## 2011 Virginia Work Area Protection Manual Revision 2 Frequently Asked Questions and Discrepancies Found

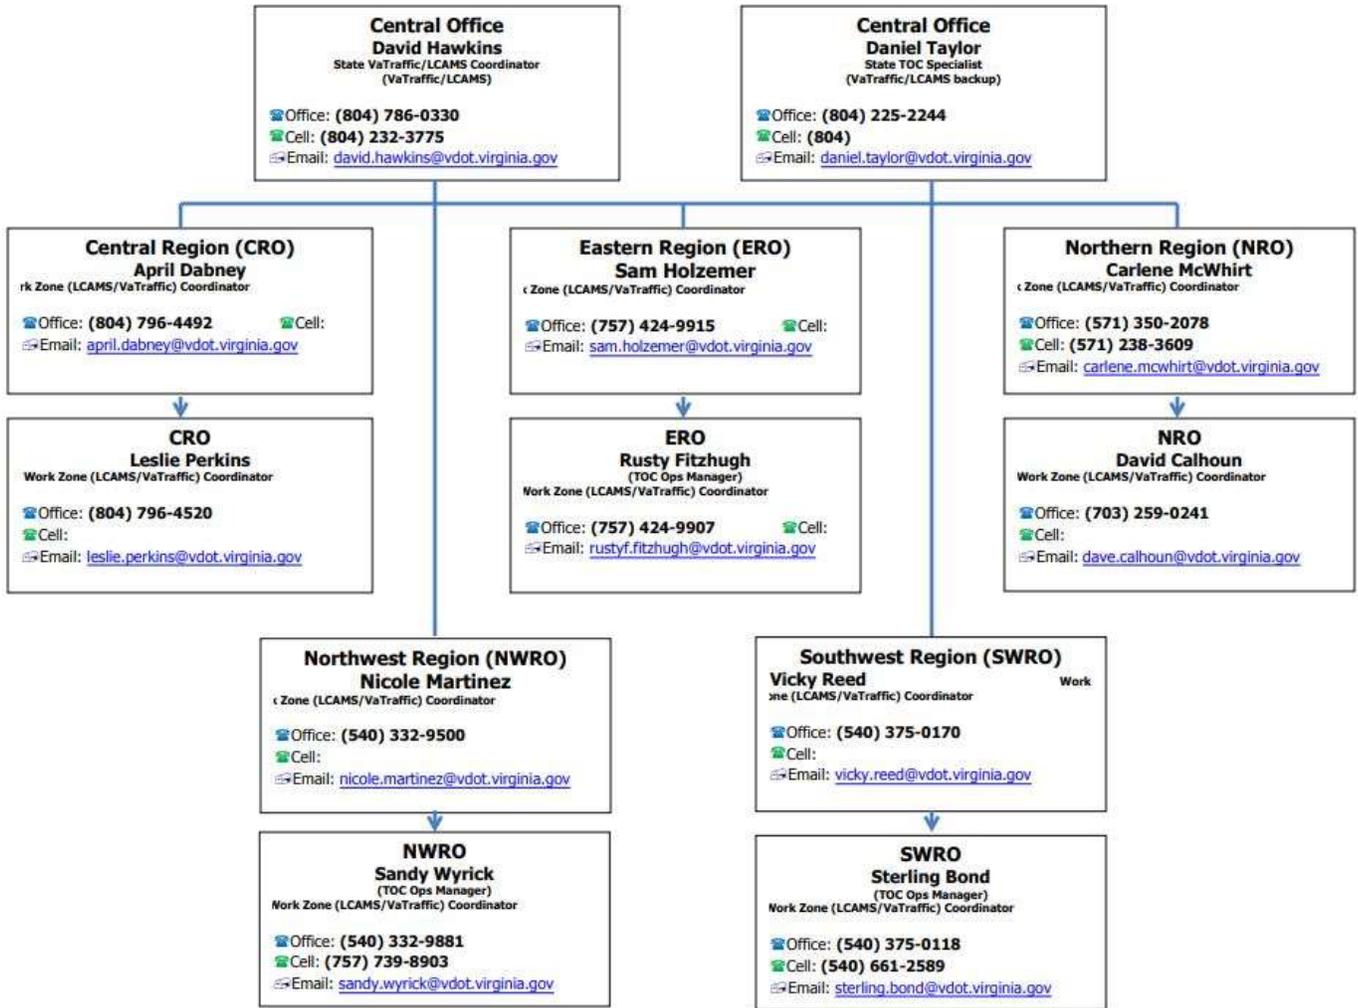
9. TTC-50 Stoppage of traffic on a Multi-lane Roadway. **We developed TTC-50.2 to specifically remove the flagger from the left side of the roadway and provide a better way to control traffic through an operation requiring periodic stoppage of traffic on a multi-lane highway. We have had several instances where flaggers have been struck performing this type of operation, especially when they have little to no room for escape on the left side of the roadway. Other states have removed flaggers from the left side of the roadway due to this fact. Traffic is better controlled when reduced to one lane, with the flagger better protected by standing in the closed right lane. It does take a little longer to install an extra set of signs and cones to close off the right or left travel lane but control of approaching motorist is greatly improved by this method. This is the preferred temporary traffic control layout to use, especially if multiple lines are being installed or multiple stoppages are needed to complete an operation. If only one line is being pulled and installed across the roadway, or only one stoppage of traffic is needed to complete an operation and there is**

ample room on both sides of the travel lanes for a flagger to safely stand and move out of the way of an errant vehicle, then the typical traffic control from TTC-50.0 may continue to be deployed.
